RE: Submission on Ivanhoe Estate Redevelopment – Stage 1 (SSD 8903)

While we are generally supportive of the proposed redevelopment, as owners of 6-8 Lyonpark Road Macquarie Park (Lot 62 DP 570271) and a key stakeholder, we wish to outline and express our concerns with respect to certain aspects of the proposed Ivanhoe Estate Redevelopment Stage 1 DA.

Figure 2 – Landscape Layout of Section AA

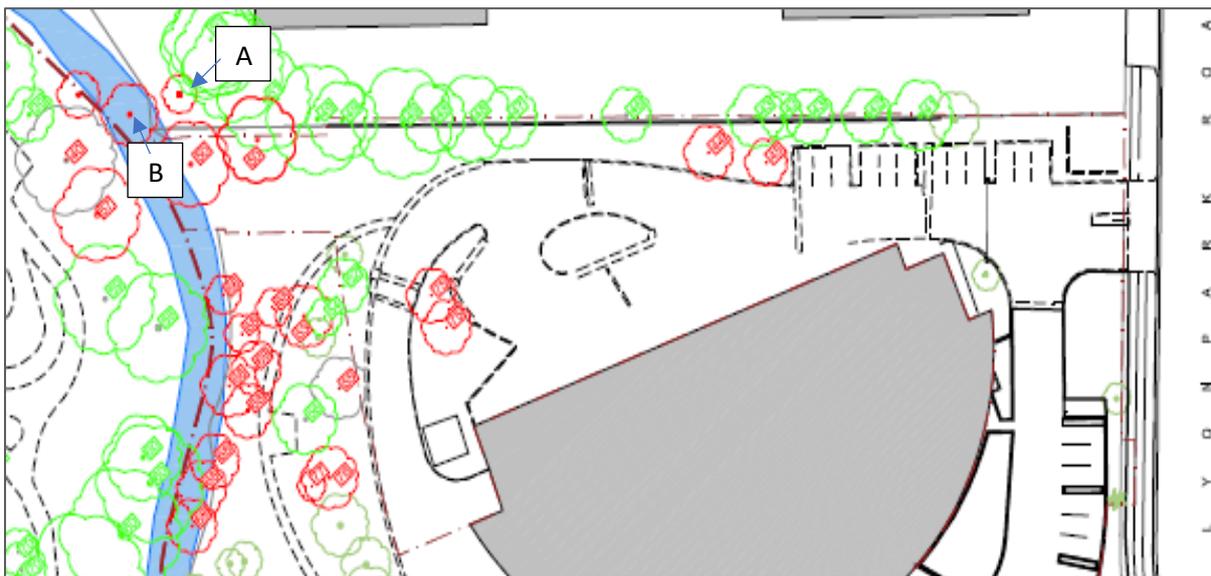
Adding to the confusion and general lack of clarity is the fact that the proposed screen is absent from the landscape layout of cross-section AA (Figure 2 below), which according to the previous layout (Figure 1), should include the proposed screen. Finally, there has been no indication of the dimensions of the screen (i.e. height, width and depth), its exact location nor the materials that will be used in its construction. Overall, this represents another major concern.

Figure 3 – Tree Removal Layout

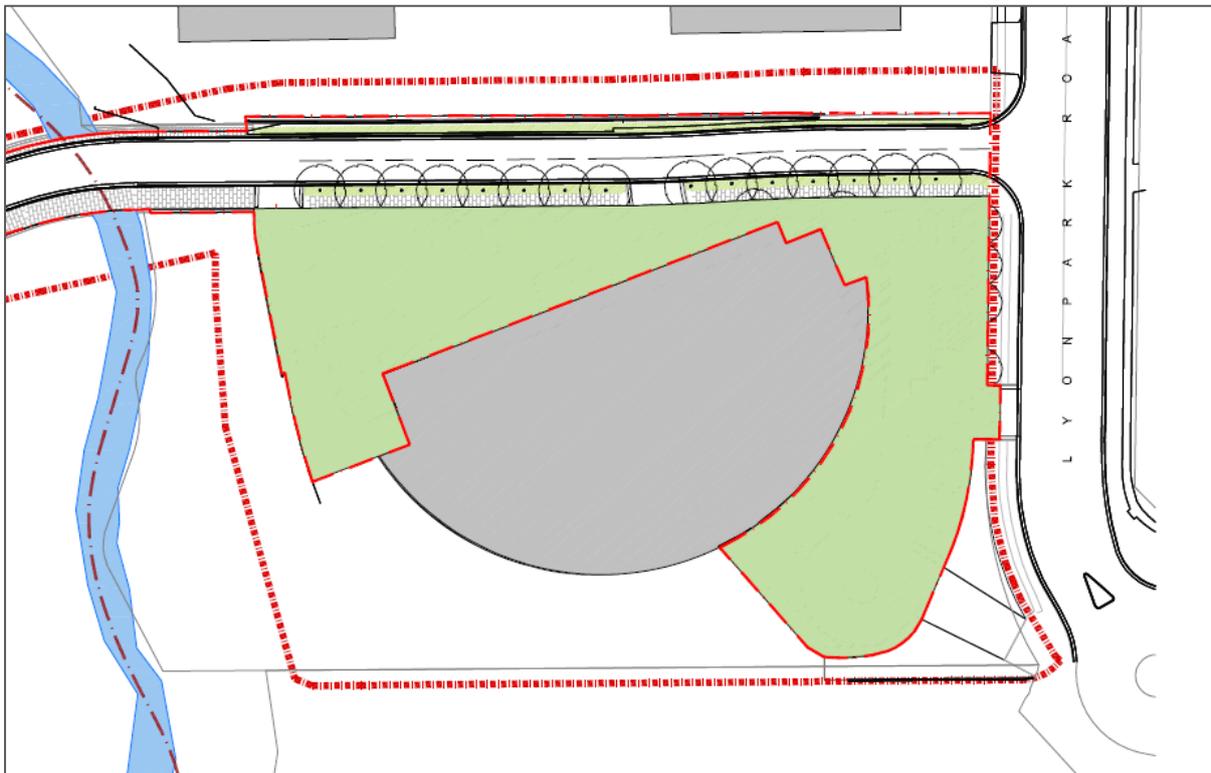
As indicated in Figure 3 below (sourced from Stage 1 Overview Drawings – Appendix A), there is tree (Item A) earmarked for removal which is clearly within the confines of 6-8 Lyonpark Road, Macquarie Park. It must be noted that we have not consented to the removal of this tree and are concerned about any repercussions that may ensue from its unlawful removal. Moreover, there is another tree within Shrimptons Creek (Item B) that could arguably be situated on our site – that is, if the *ad medium filum legal* precedent applies.
